Submission Regarding Part 3A Application 09_0175

Karuah East Quarry Project

Prepared for Boral Property Group | 19 April 2013

Report J13031RP1 | Prepared for Boral Property Group | 19 April 2013

Figure 5.1 Comparison of 24-hour PM₁₀ concentration in lower Hunter (2006 – 2008)

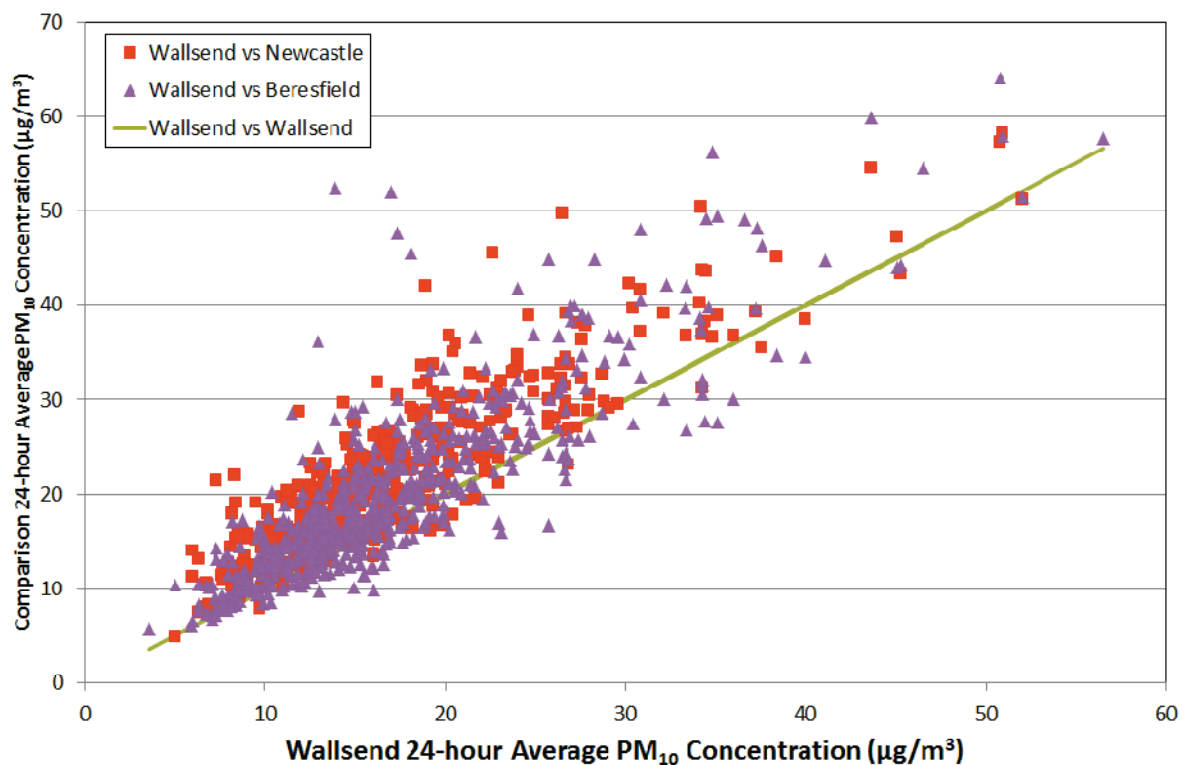
A scatter plot of the 24-hour average PM₁₀ concentrations recorded at Wallsend paired with the coincident concentrations at Newcastle and Beresfield is presented in Figure 5.1. The scatter plot highlights that, while the concentrations experienced at Newcastle and Beresfield are typically higher, there is a strong agreement with the concentrations recorded at Wallsend, despite the spatial distance between the monitoring sites. Further the calculated correlation coefficient, a measure of the strength of relationship between two datasets, between the Wallsend and Newcastle and Wallsend and Beresfield datasets is 0.88 and 0.86 respectively (a value of 1 implies a strong relationship).

It is therefore considered that, due to the similarity in concentrations with other monitoring datasets in the Lower Hunter region, the Wallsend dataset provides a good measure of regional particulate matter concentrations. It is considered that the use of the Wallsend dataset in representing background PM₁₀ concentrations attributable to regional sources is valid.

Figure 5.2 Wind rose data used for assessment compared against the Karuah Quarry HVAS wind direction data

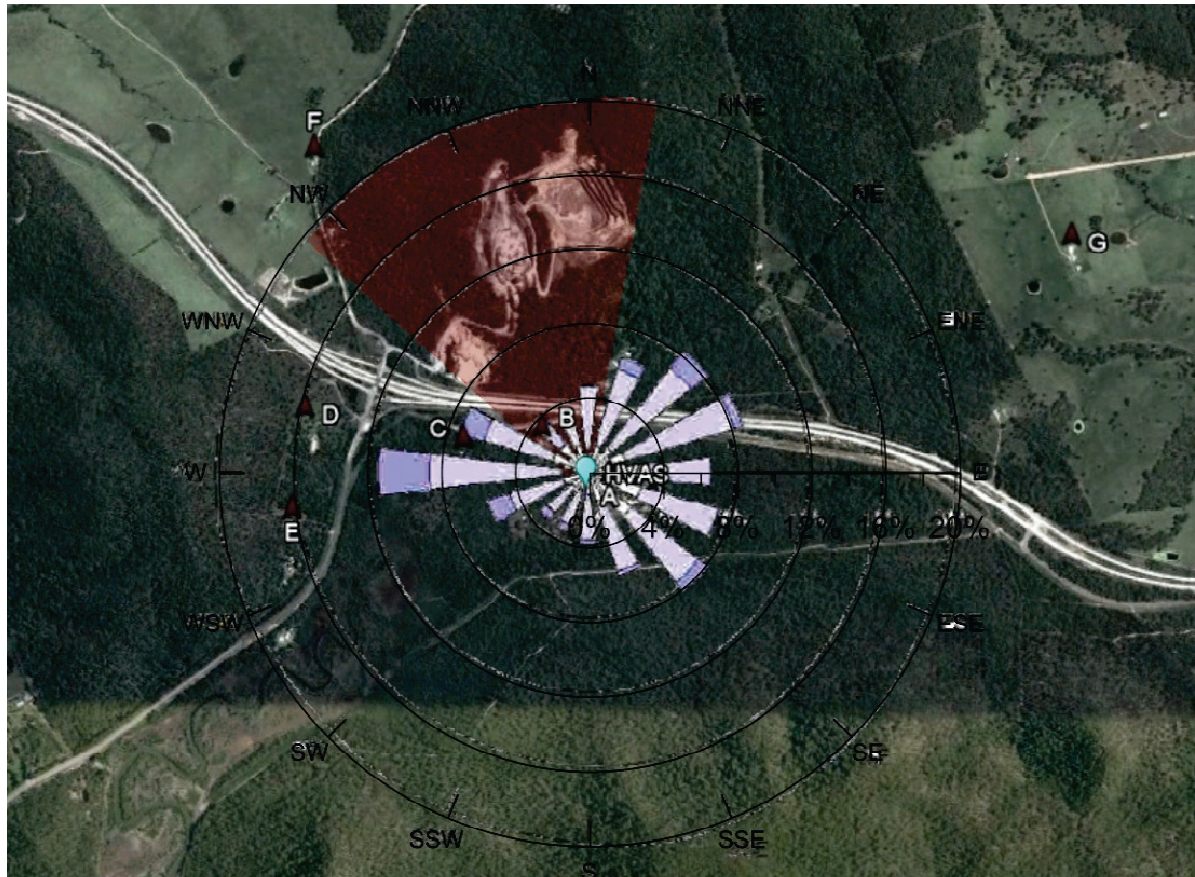
The annual wind rose predicted for the Karuah East Quarry site (Figure 11 in the AQGGA report) is presented in Figure 5.2, overlaid on an aerial photo of the site. Also marked are the seven sensitive

receptor locations, the HVAS location where TSP and PM₁₀ concentrations were recorded and the critical wind direction range where the HVAS is downwind of the existing Karuah Quarry.

It can be seen from Figure 5.2 that the HVAS monitoring location is downwind of the existing Karuah Quarry when winds are from the north-west to north. Based on the predicted annual wind rose for the site presented in Figure 11 of the AQGGA report, winds from this direction occur approximately 11% of the year.

Figure 6.1 NM1, Monday 15 September 2003

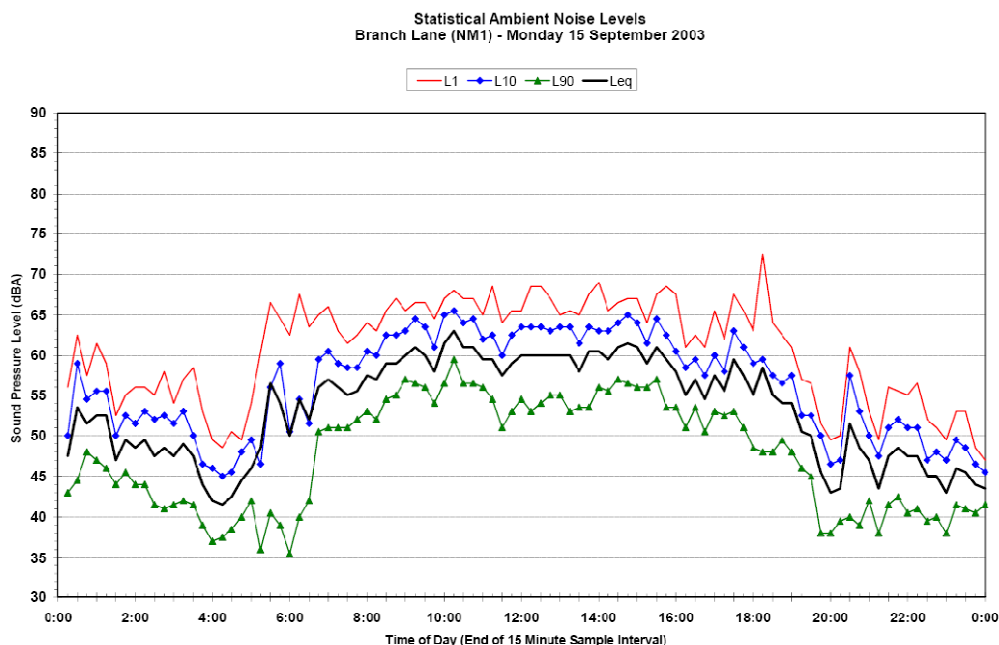
attended surveys identify quarry noise contributions that influence the L_{90} metric that are used to derive the PSNL's. Therefore, the data was not assessed in accordance with the INP and is 'not suitable baseline data' as per the DGRs. The expected outcome is that the noise criteria should be lowered to account for the quarry noise contribution to NM1 and NM2 derived criteria. It is noted that NM1 is owned by the quarry, however the data from this location has been used to derive criteria for surrounding receivers.

It is clear from the noise logger charts that some quarry influence occurs to ambient levels at the time of the quarry start up (7 am), see Figure 1 reproduced from Appendix C of NBIAR. In Figure 6.1 it is evident that some 'morning shoulder' traffic noise from the highway is present (representative of the L_{eq} metric), however the L_{90} metric increases by approximately 17 dB(A) in the hour from 6 am to 7am, clarification is sought to demonstrate that the quarry was not influencing the ambient levels that were used to determine the PSNL as per the INP.

Figure 6.2 NM1, Thursday 11 September 2003

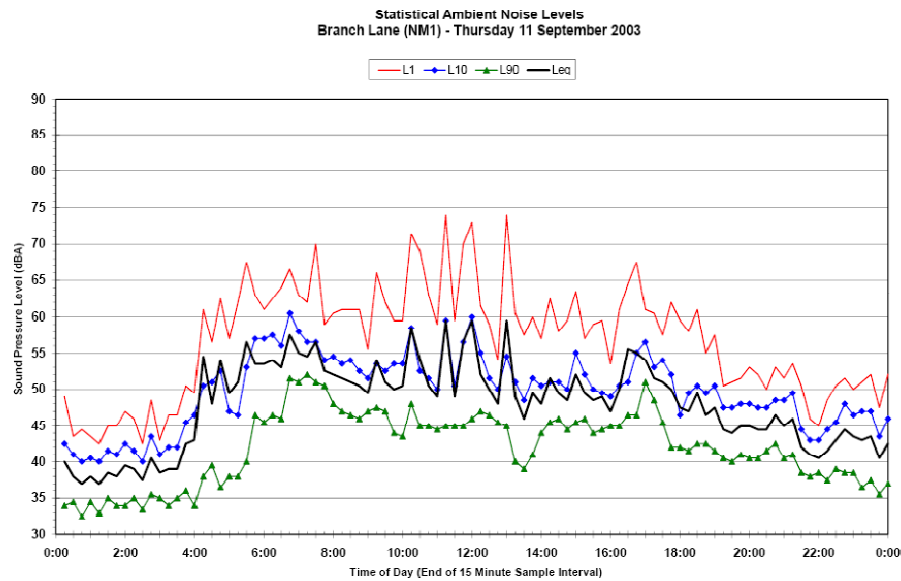
It is considered that ambient data for NM1 and NM2 are on occasion affected by winds above 5 m/s and rain (see Figure 6.2 and Figure 6.3). Clarification is sought regarding the exclusion of these periods from derivation of the rating background levels (RBL). If not, the PSNLs have not been assessed in accordance with the INP. Furthermore, it is unclear to the reviewer the age of the meteorological data used in the assessment. If the data was from 2003, it is arguable that the data is no longer representative of the subject site (ie not suitable baseline data) as per the DGR's.
